11-AFC-4

Dr. Sönke Johnsen, Ph.D
Professor of Biology, Duke University

PSA equations for heating and cooling

I, Karen A. Mitchell, declare that on December 5, 2012, I served the attached *December 5 2012 CEC Workshop Presentation by Dr. Sonke Johnsen* via electronic and U.S. mail to all parties on the attached service list.

Wings Flap!

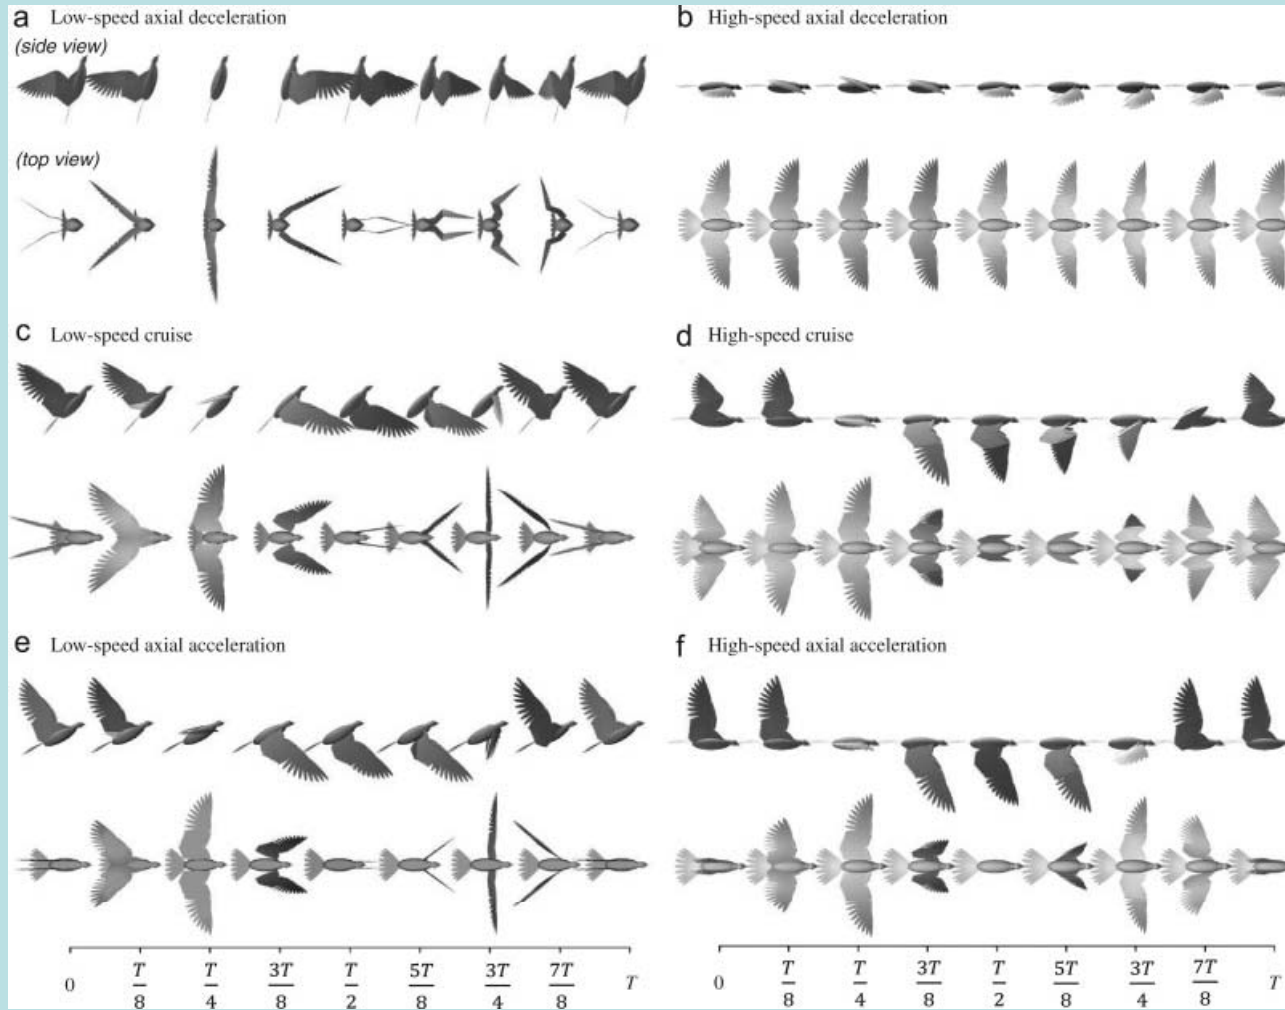
- Equations presented in the PSA are incorrect.
- Revised analysis presented here represents a reasonable, yet very conservative lower bound for flux effects.
- Wing flapping may significantly effect the heat transfer coefficient further reducing potential for flux effects.
